CALLEGUAS MUNICIPAL WATER DISTRICT
Thousand Oaks, California

PROJECT NO. 450

FOR THE CONSTRUCTION OF THE
LVMWD-CMWD INTERCONNECTION

ADDENDUM NO. 2

Adopted by the Board of Directors of
Triunfo County Sanitation District

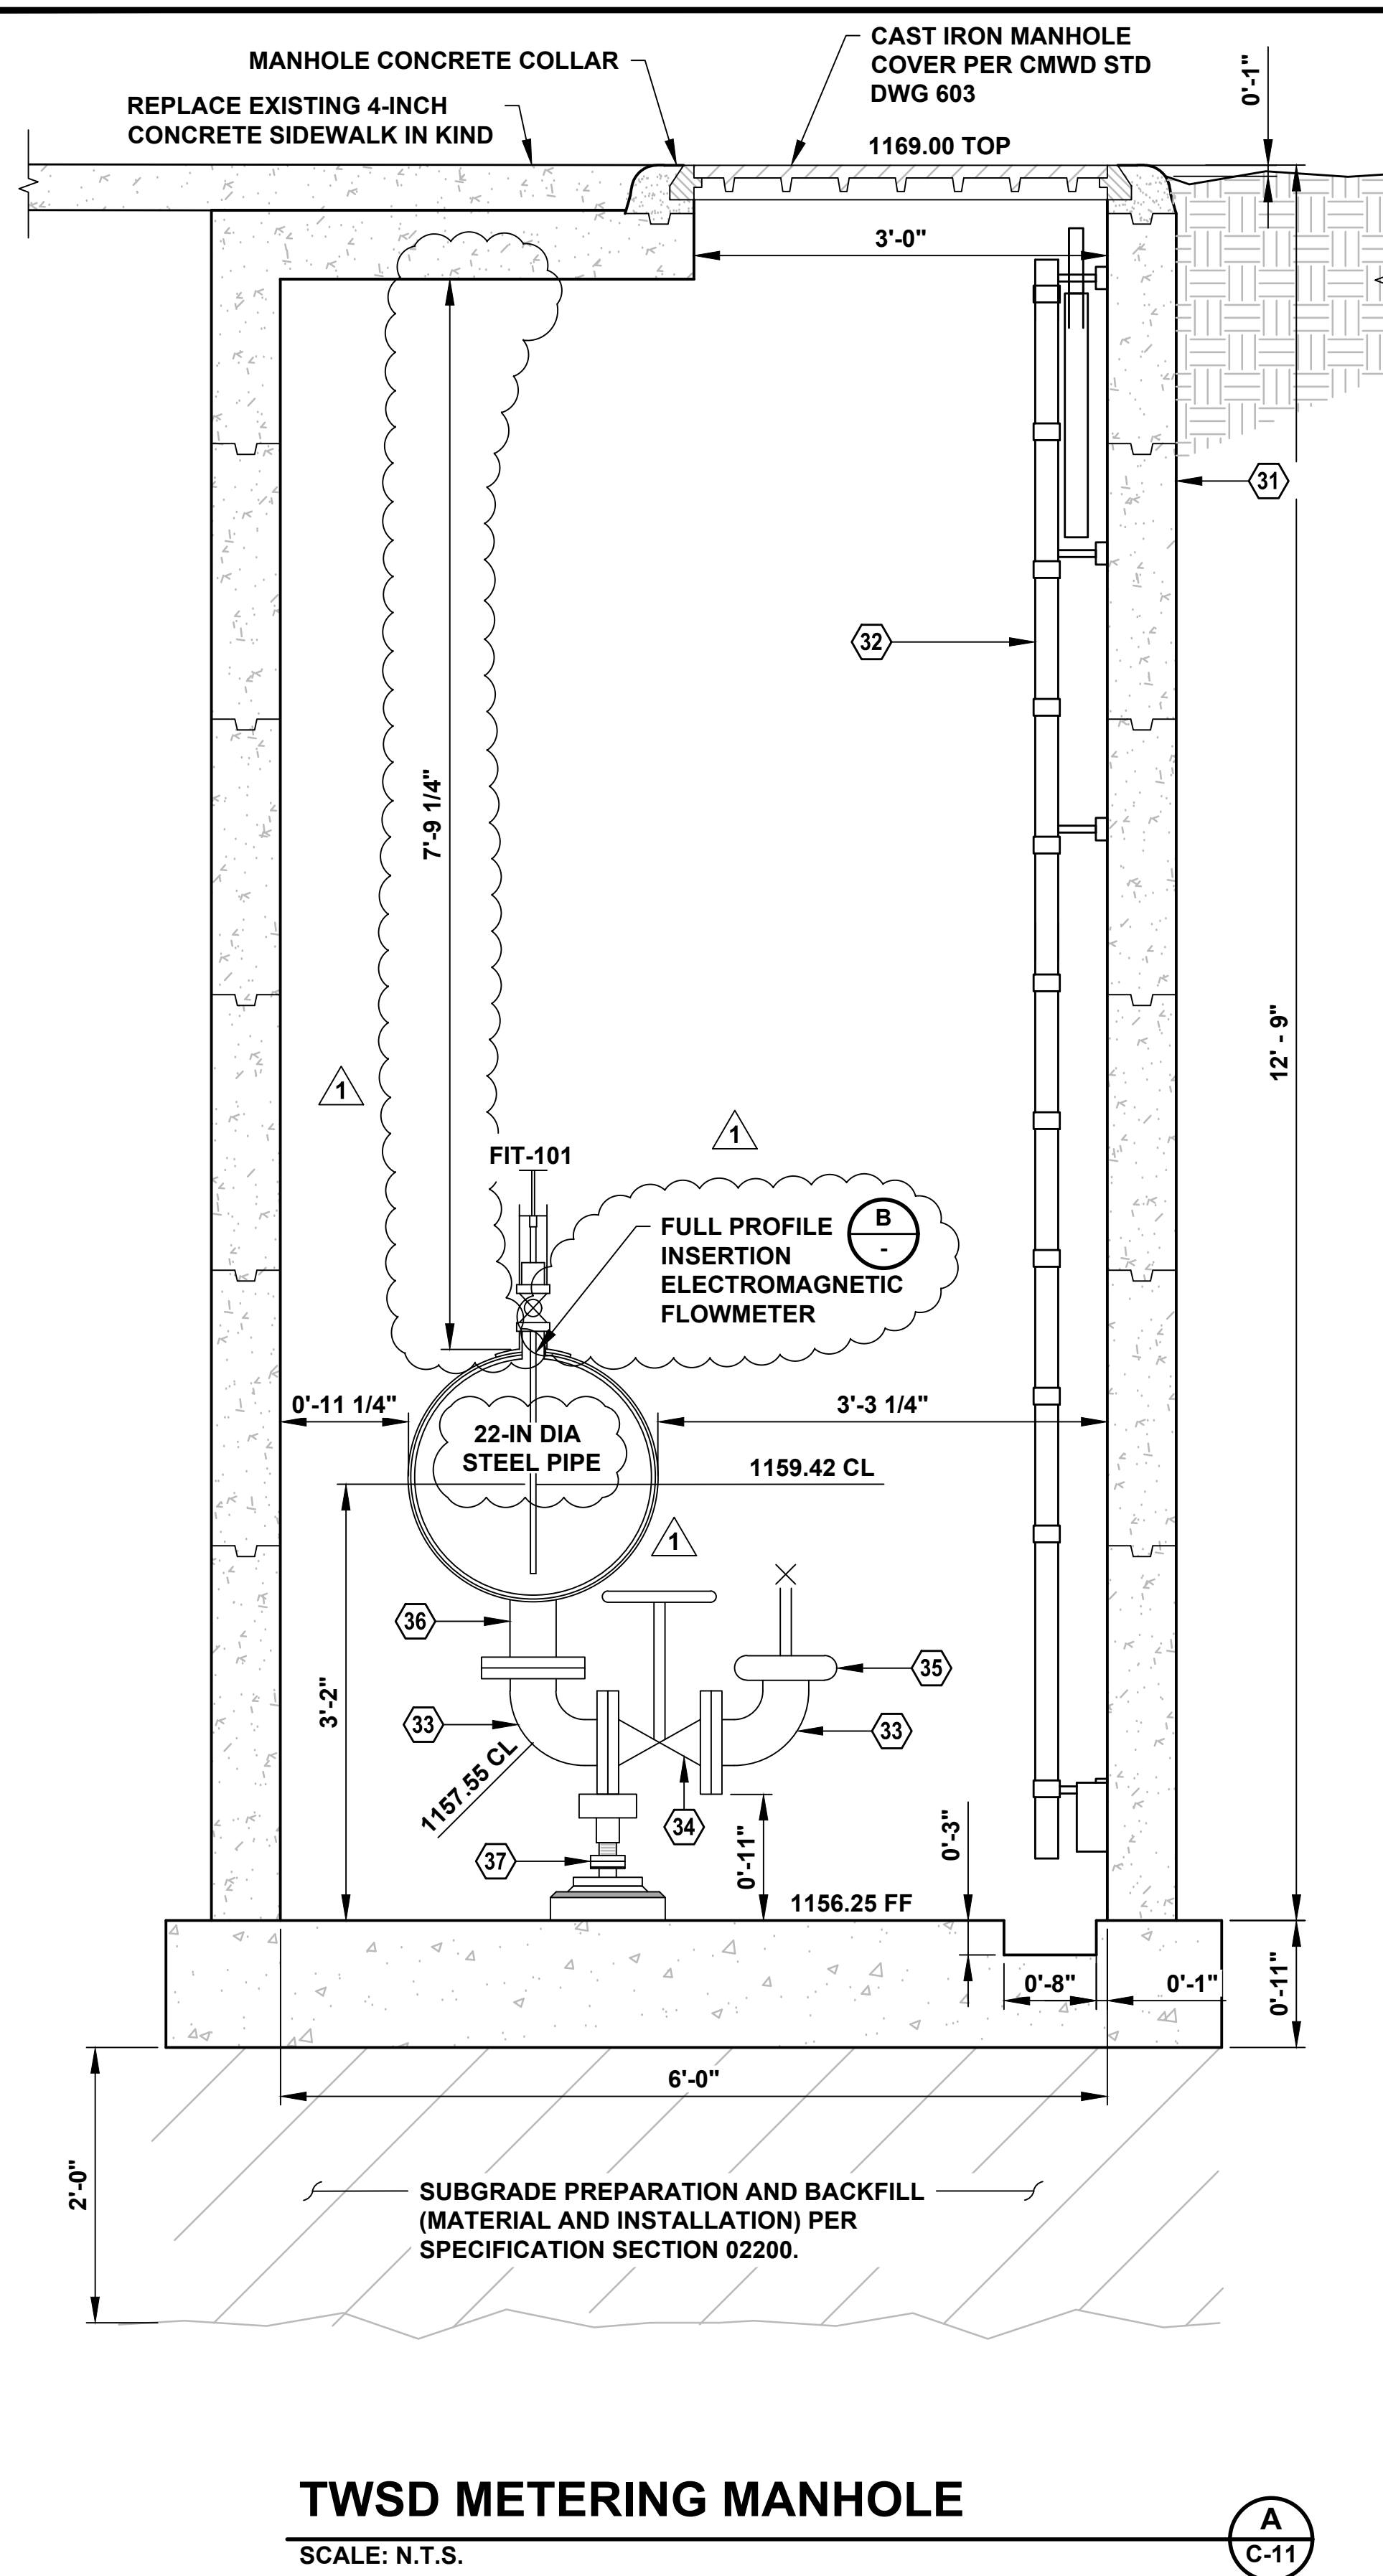
- Item AD2-48 DELETE all note callouts which state “4-INCH DIA” on Drawing C-12, Detail E, and replace with “1.5-INCH DIA.”
- Item AD2-49 REPLACE Drawing C-13 with the attached Exhibit H1, containing replacement Drawing C-13.
- Item AD2-50 REPLACE Drawing C-17 with the attached Exhibit H2, containing replacement Drawing C-17 and new Drawing C-17A.
- Item AD2-51 INSERT the following note at STA 2+69.82 on Drawing C-19:

DRAWING NO. C-31
JOB NO.
SHEET 37 OF 127

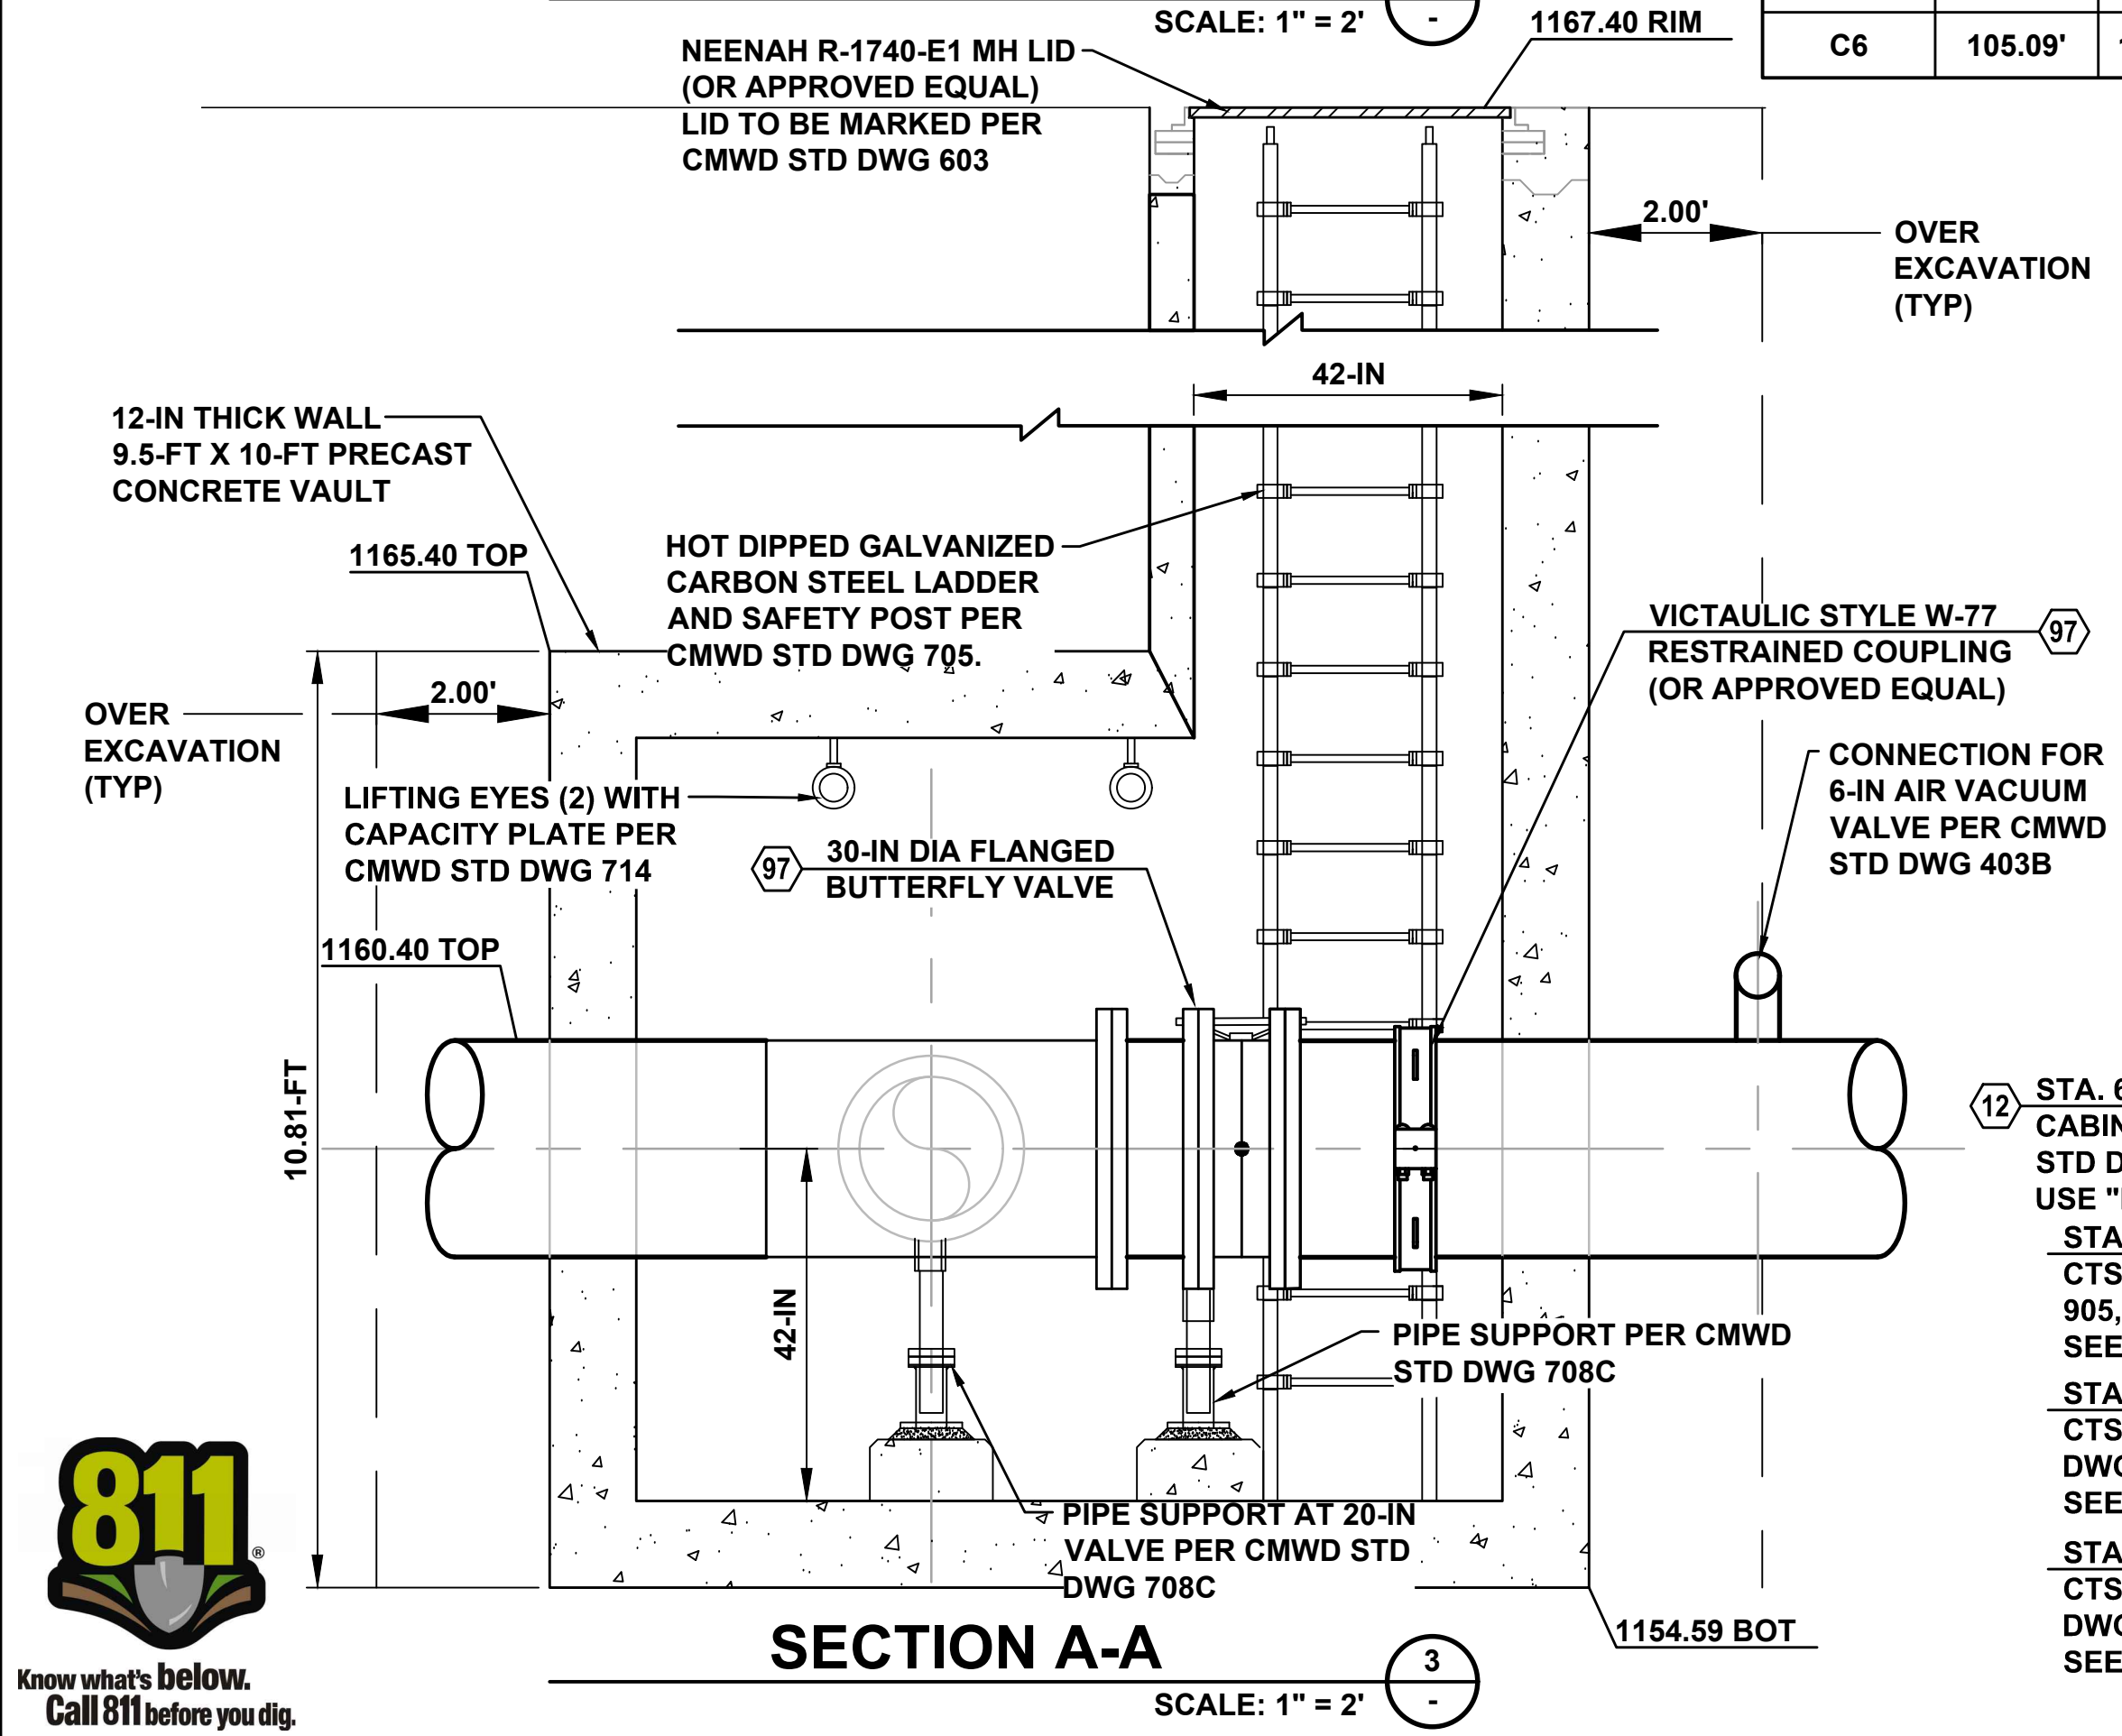
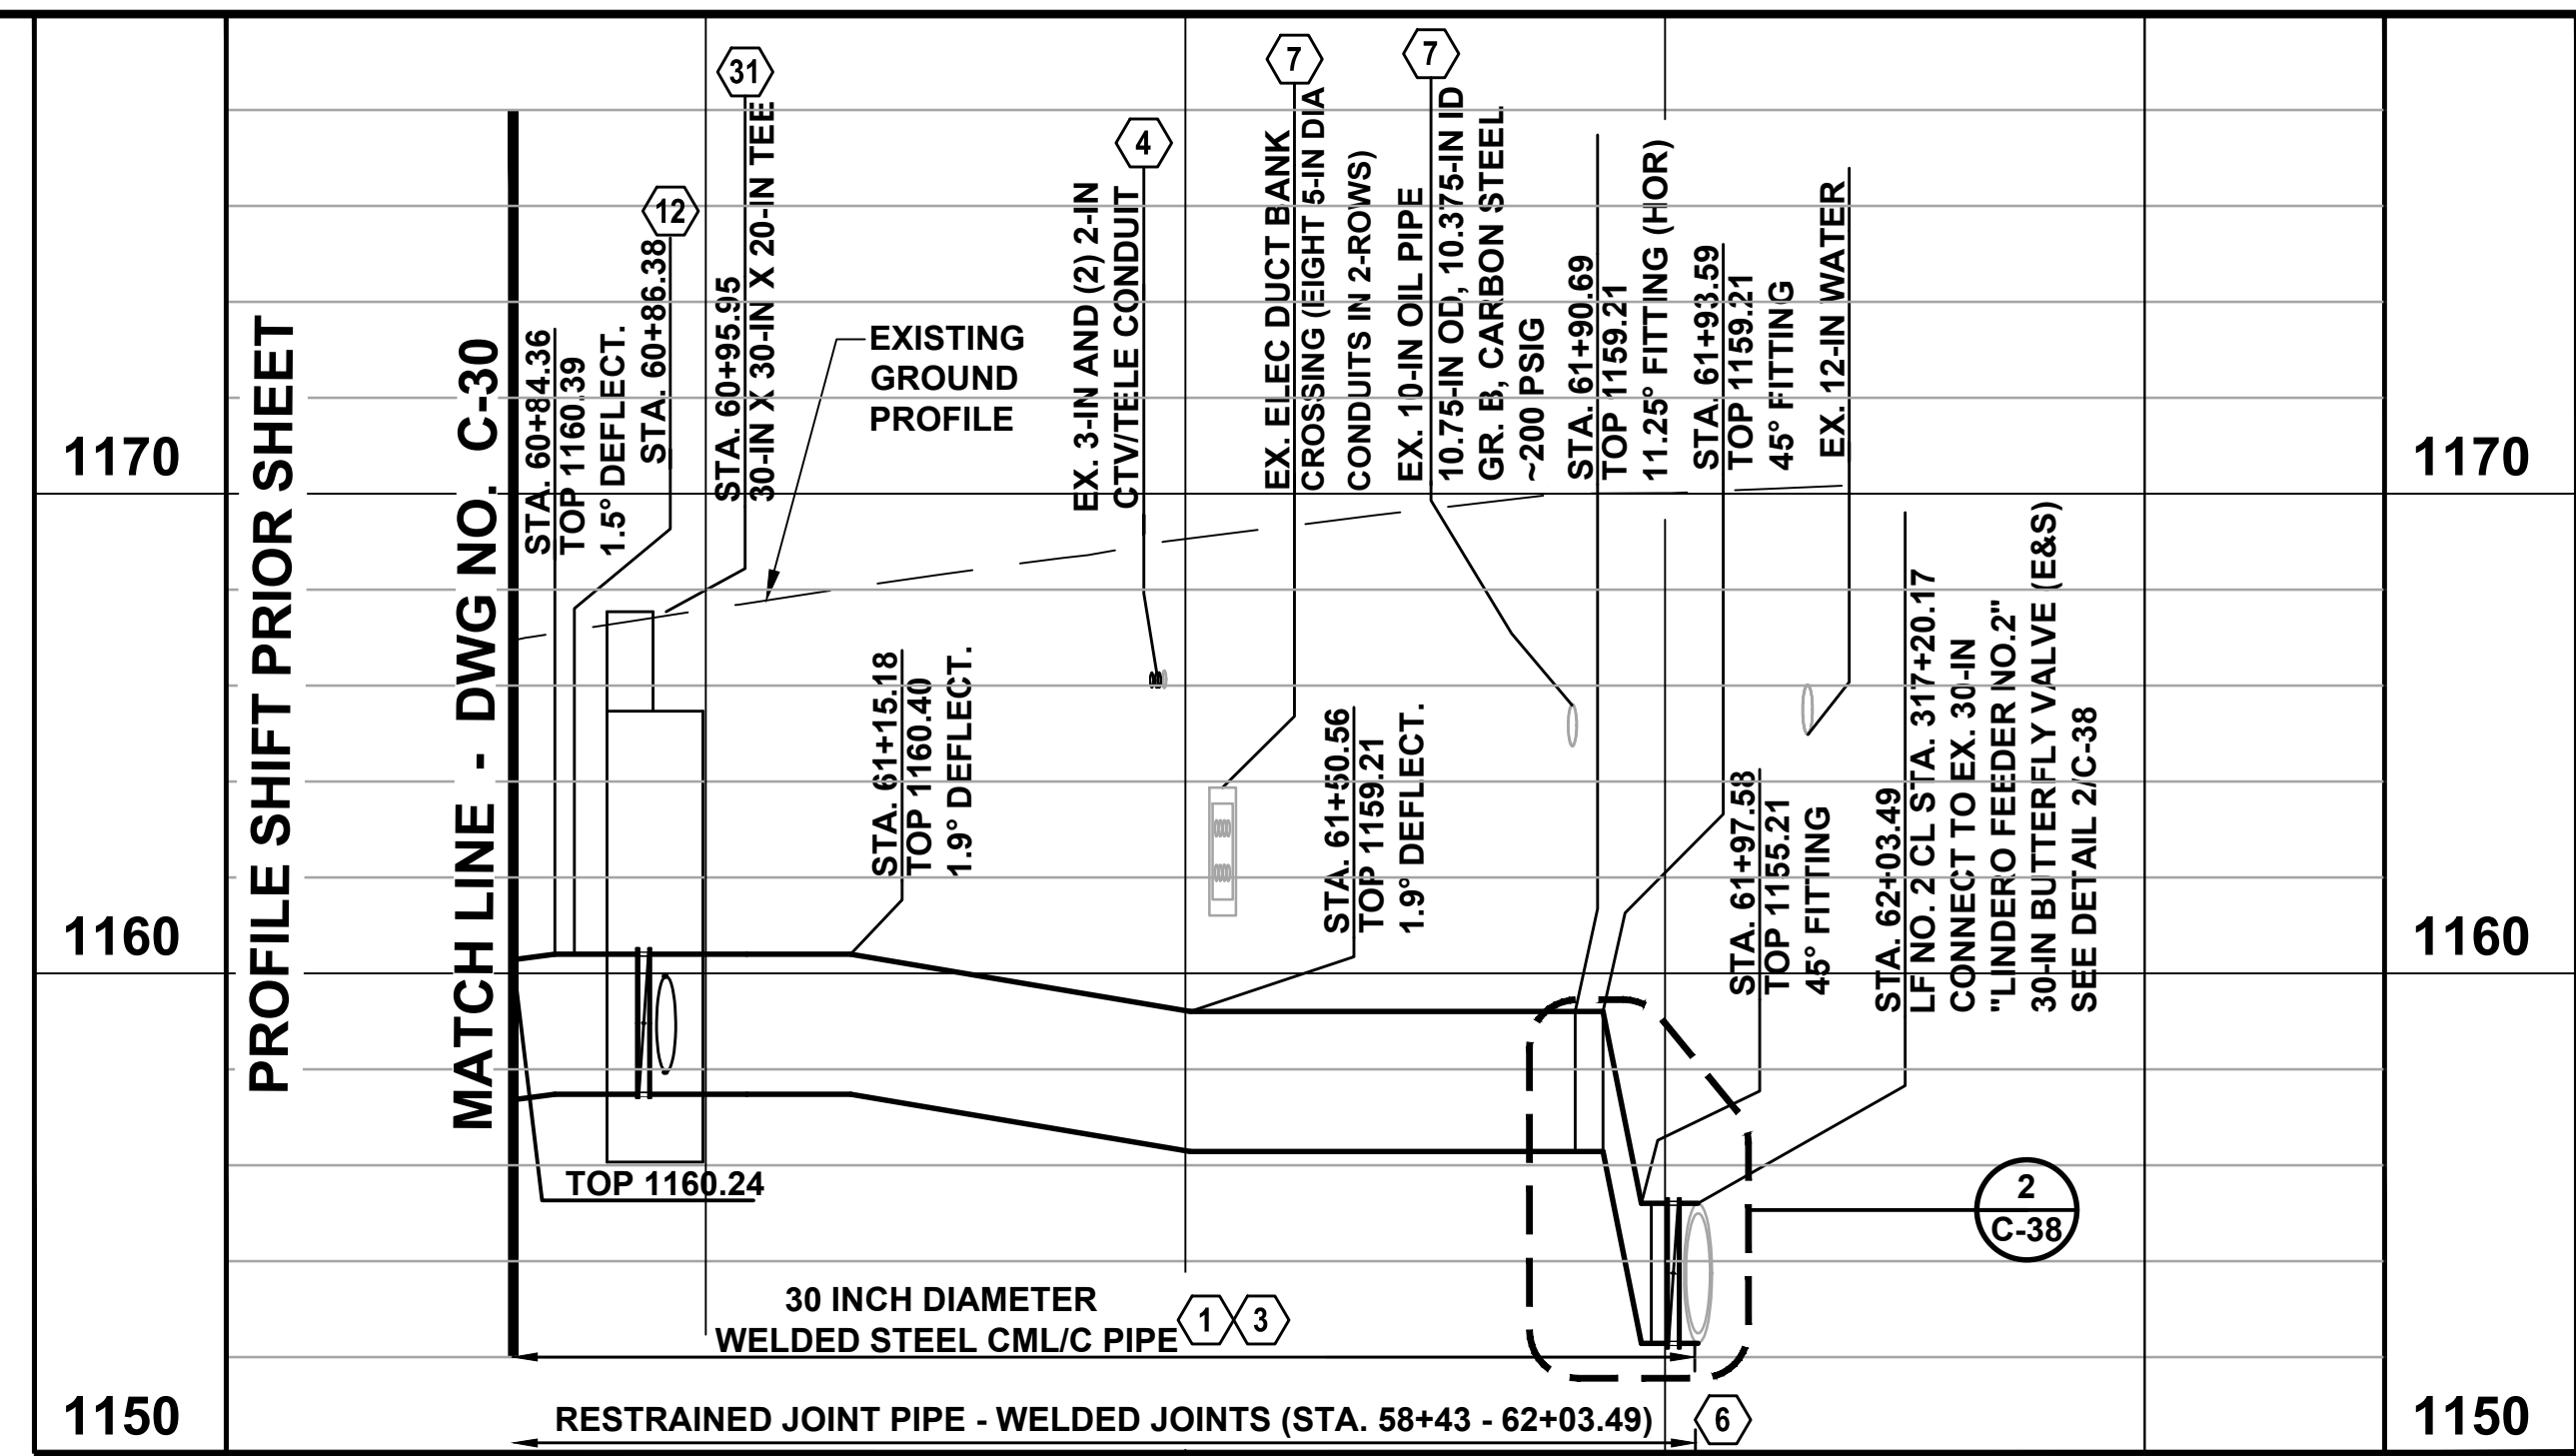
“NO JOINTS IN THE PIPE SHALL BE PLACED WITHIN 10 FEET OF THE SANITARY SEWER UNDERCROSSING LOCATED AT APPROXIMATELY STA 47+06.”
- Item AD2-53 REPLACE Drawing C-31 with the attached Exhibit H3, containing replacement Drawing C-31.
